**CITY OF AVON LAKE  
PLANNING COMMISSION  
150 Avon Belden Road  
Avon Lake, Ohio 44012  
(440) 930-4110**

**Work Session Agenda  
Tuesday, October 7, 2025  
Following Planning Commission Meeting  
City Council Chambers**

**SUBJECT:** CPC-25-15 Calvary Court Subdivision Preliminary Plat

## Engineering Review – Chris H. & Coleen S.

**PRELIMINARY**  
**GRADING PLAN**

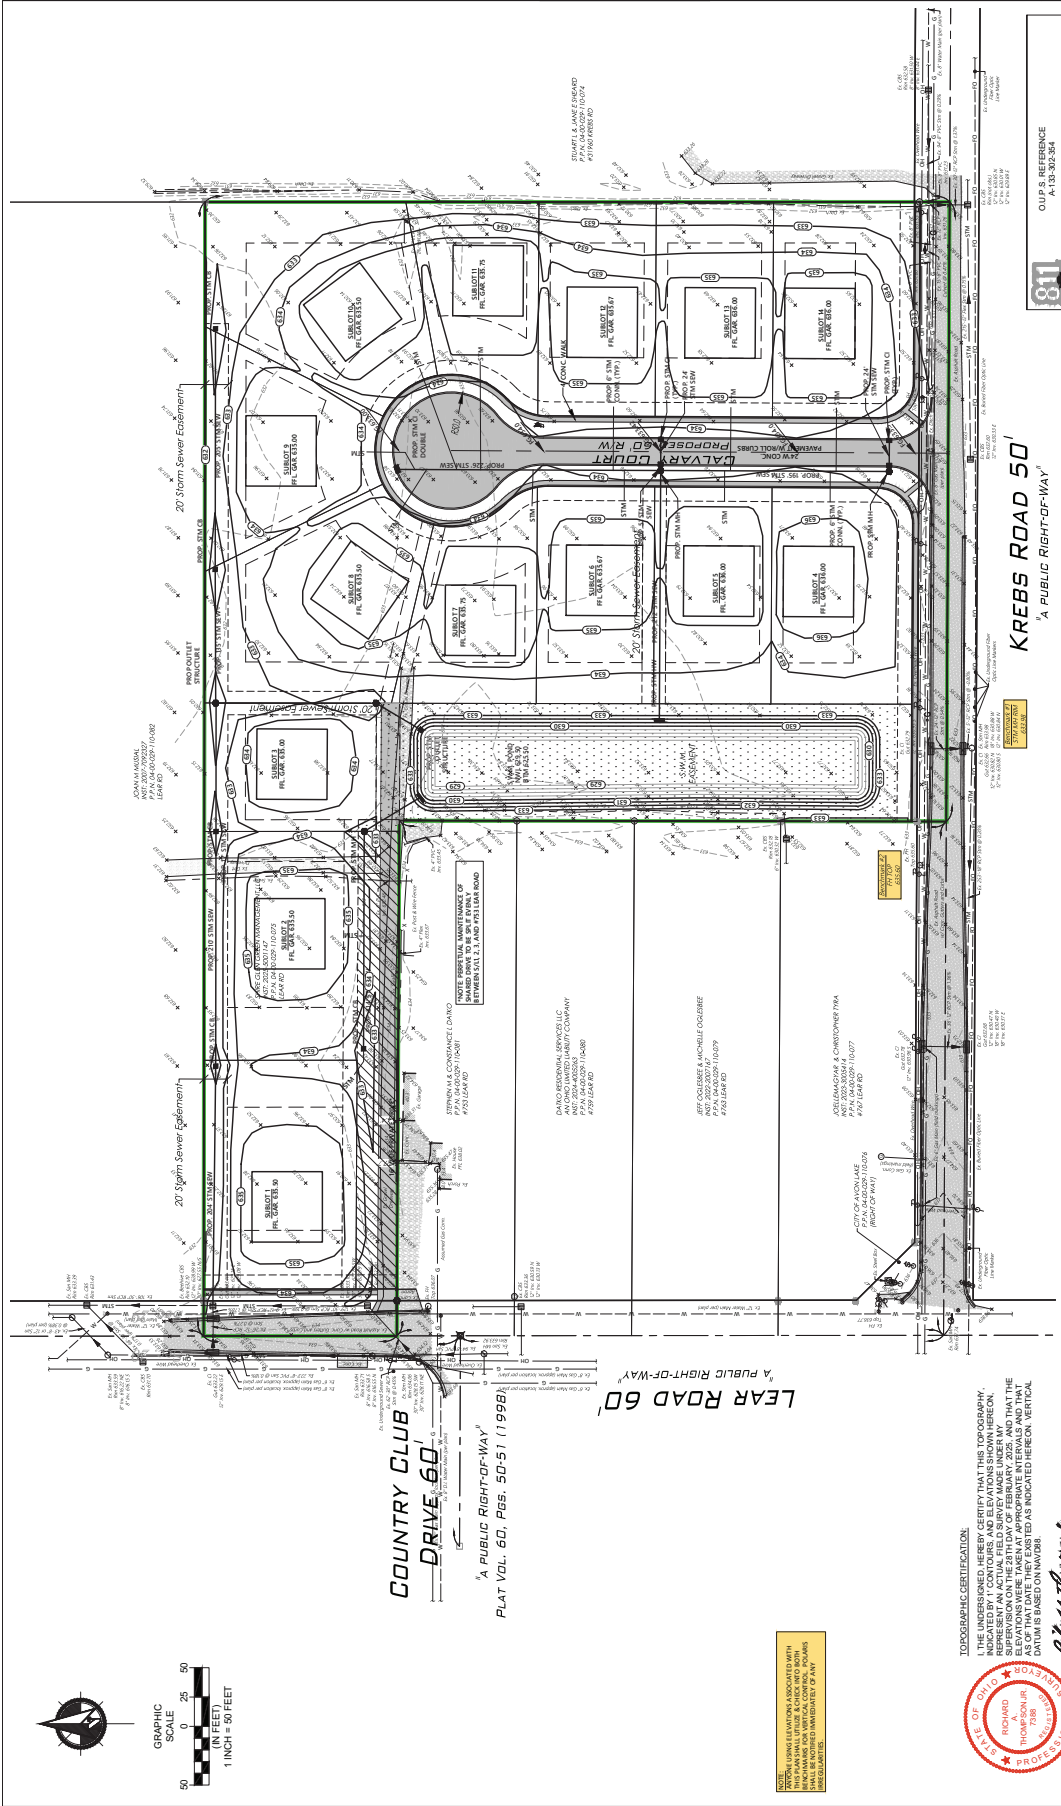
Was a Wetland Delineation prepared for the subject property? If so, please provide a copy. We would recommend that the Proposed Stormwater Management Facility not be included within S/L 3 and be within a Block. Will there be an HOA for the Proposed Subdivision? Who will be responsible for the maintenance of the Proposed Stormwater Management Facility. Concerns with Sublots 1-3. Per Section 1226.01(e)(8)(A-F), the stacking of flag lots shall be prohibited. Flag lots shall be discouraged and shall only be approved if necessitated by unique topographic features or other special physical conditions as deemed necessary by the Planning Commission. How will access be provided for Safety Services (i.e., fire trucks). The Proposed Pavement width shall be 27' from back of curb to back of curb on public streets. In addition, the pavement shall be 8" thick concrete over 6" aggregate base. On Sheet 3, Preliminary Plat, double check the frontage for S/L 8. The minimum lot frontage, along the Right-of-Way shall be 60'. On Sheet 3, Preliminary Plat, double check the frontage for S/L 12. The curve data is missing at the northwest corner along the frontage (south of C9). On Sheet 5, Preliminary Grading Plan, provide rear yard drains.

PRELIMINARY PLAT

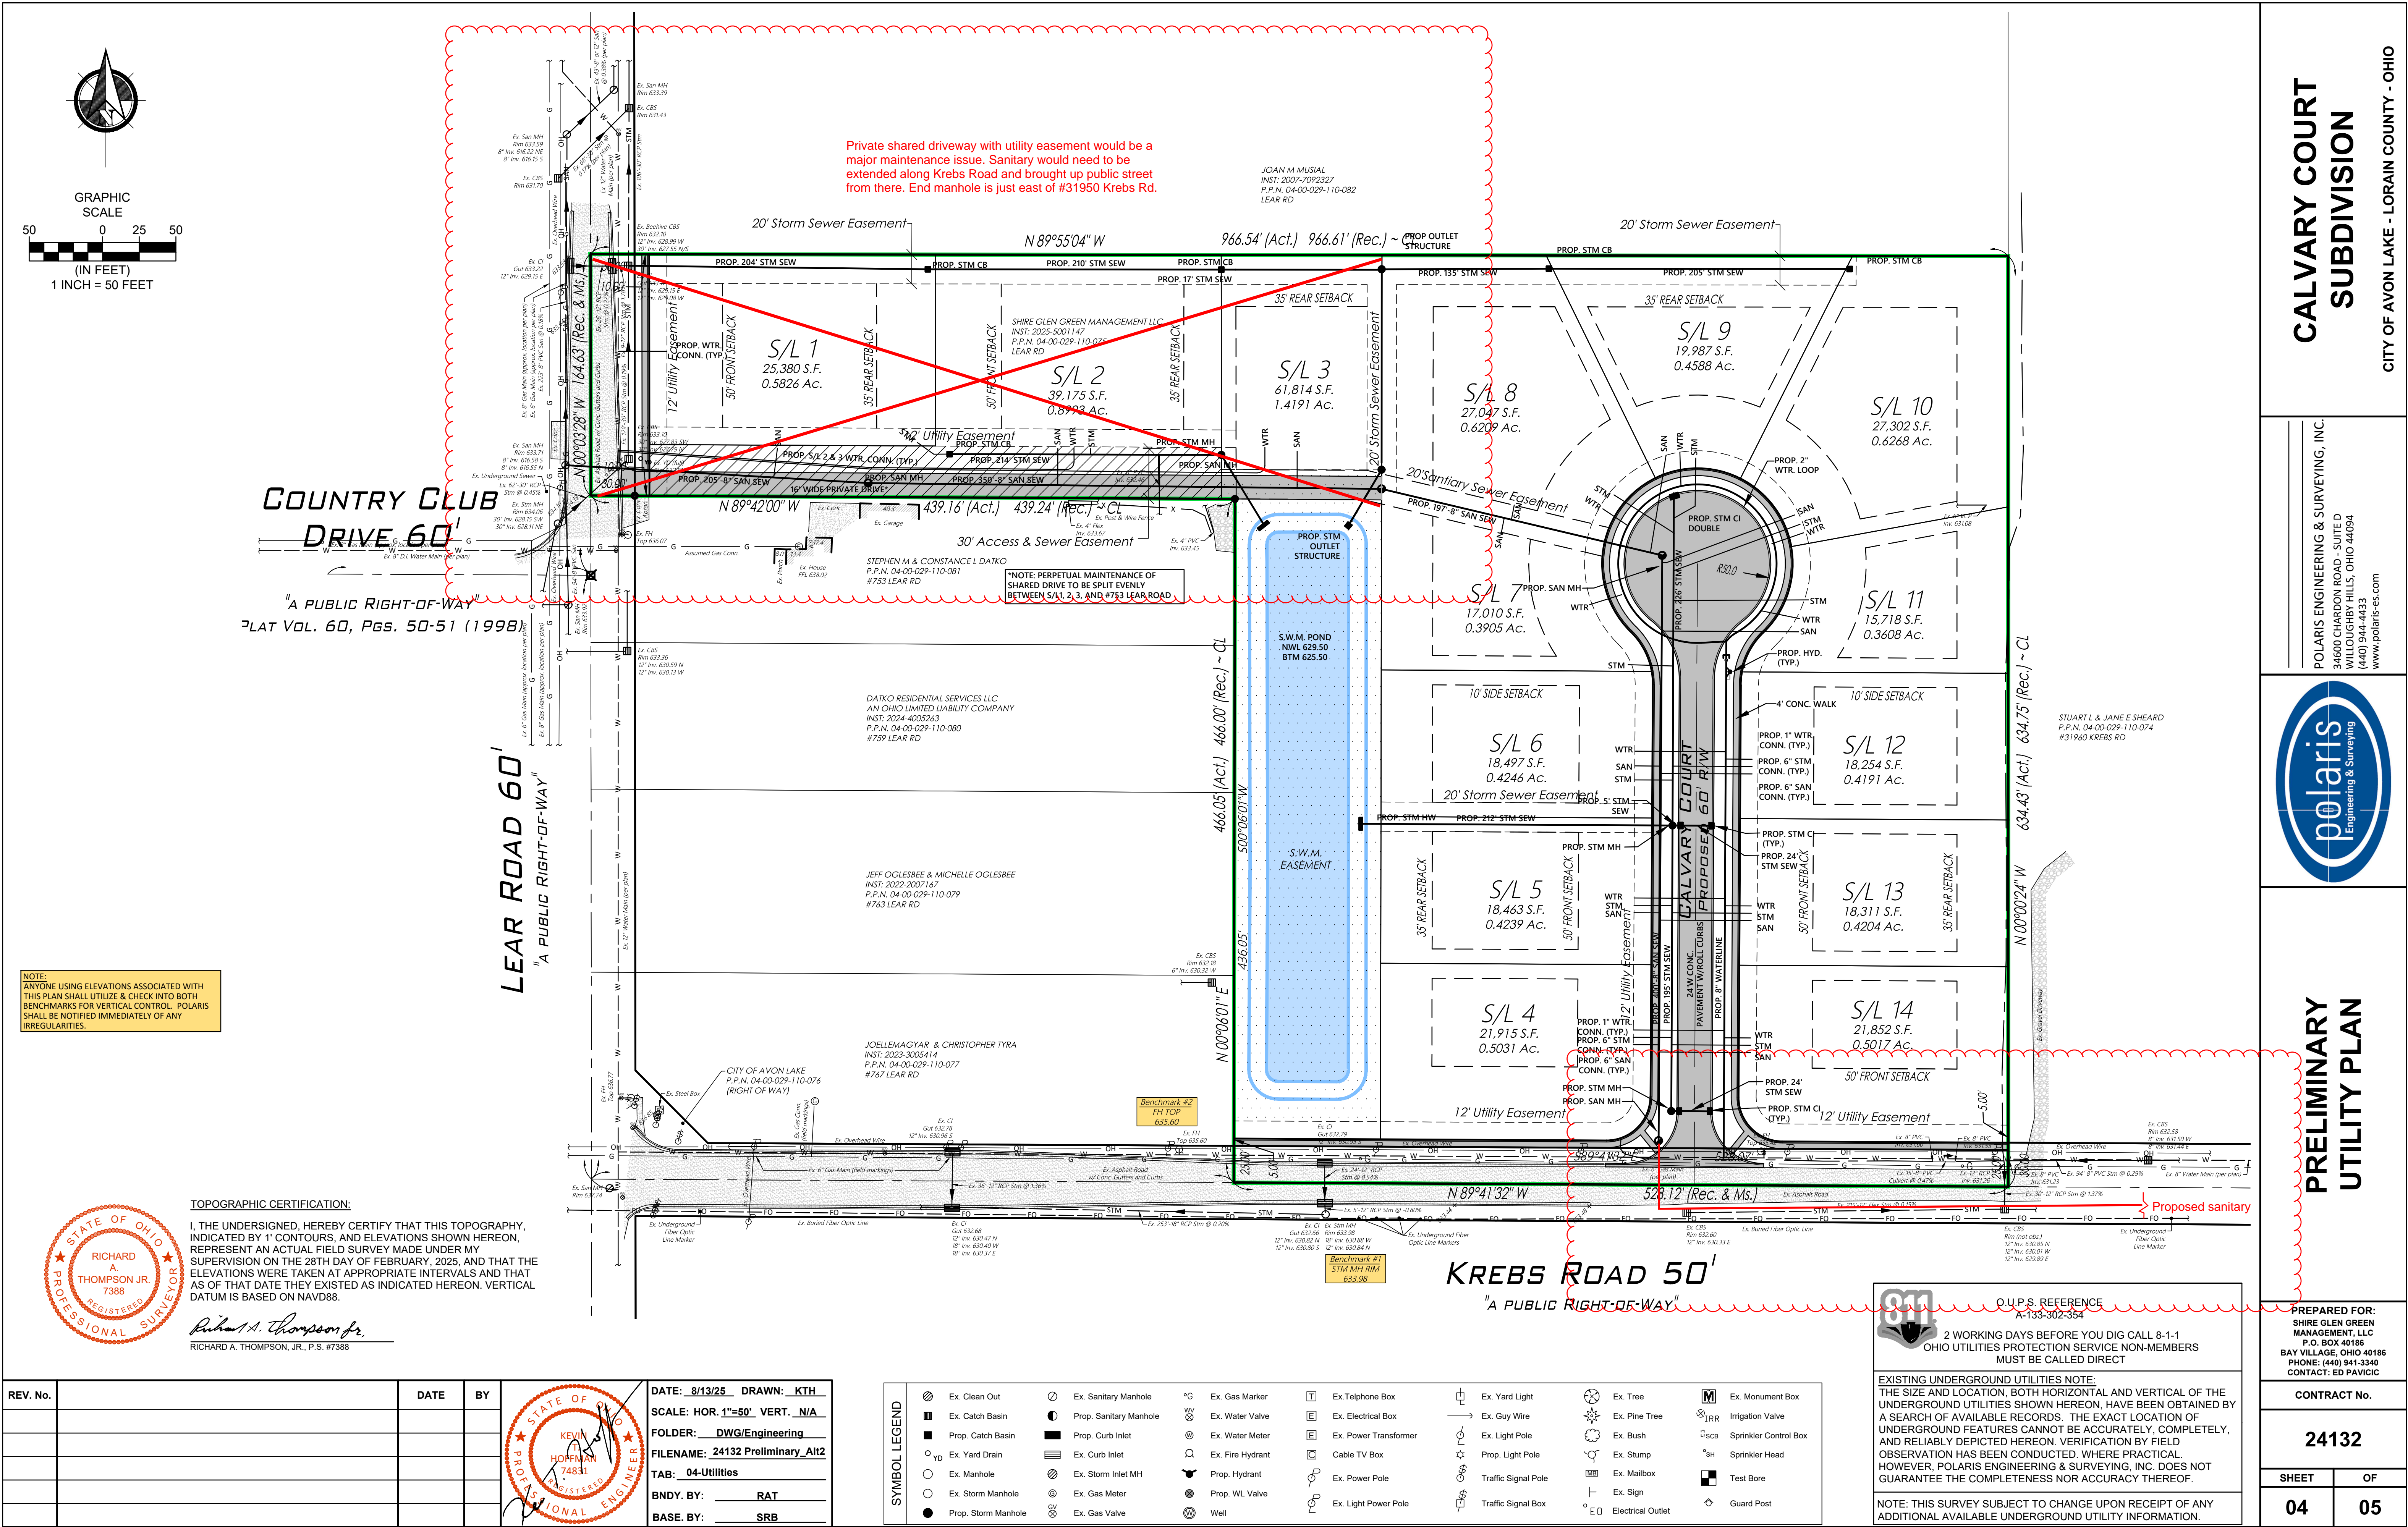
1. Please provide the various easement notes to the planset.
2. Sidewalks are depicted on other plan sheets but please depict on plat sheet (3/5).
3. Is there a proposed HOA?

4. Will need to discuss Lot 3. Who is going to be responsible for the maintenance of the retention?
5. Stacking of panhandle lots shall be prohibited. 3 lots will not be permitted as depicted. However, is it really stacking if the lot extends all the way to Krebs Rd. Unique situation. Please allow for more comments on this matter.

6. If sub lot 3 is permitted, the home should front south, based on the setbacks, as depicted on the plat. Please know if the house faces west, it would create a shallow buildable depth because of the 50' front setback (from lot 2 shared lot line) and the 35' rear setback adjacent to Lot 8.

7. Per Code, Panhandle lots (flag) lots shall be discouraged and shall only be approved if necessitated by unique topographic features or other special physical conditions as deemed necessary by the Planning Commission. PC will need to confirm there is no issues with the panhandle lots (1-2).

8. The panhandle shall have a minimum width of 20 feet along the entire width of the panhandle. The maximum width shall be 40 feet and, anything with a width of 40 feet or greater shall be considered an interior, corner, or double frontage lot as may be applicable. Plans show 35', so no issue there.

9. A note should be added to the plat stating that no structures, except fences and walls, are permitted in the panhandle portion of the lot.
10. The lot square footage calculations should not include the panhandle portion of the lot. Lot 2 will need to be revised.

13. Lots 4 & 14 will not be permitted a drive onto Krebs Road and access will be from Calvary Court. Lots shall front Calvary Court based on the setbacks. Please label "front" on Calvary Court. Not to be addressed now but would recommend a design for these homes that depicts a secondary frontage rather than just a large vertical side wall when entering the subdivision. Driveways will also need to non the northernmost portion of these lots, furthest away from the intersection.

16. The private drive for the pannahndle lots will need to be paved and will need a curb along the southside as it appears to be depicted alongside the property line. Required per code when there is a 0' setback.
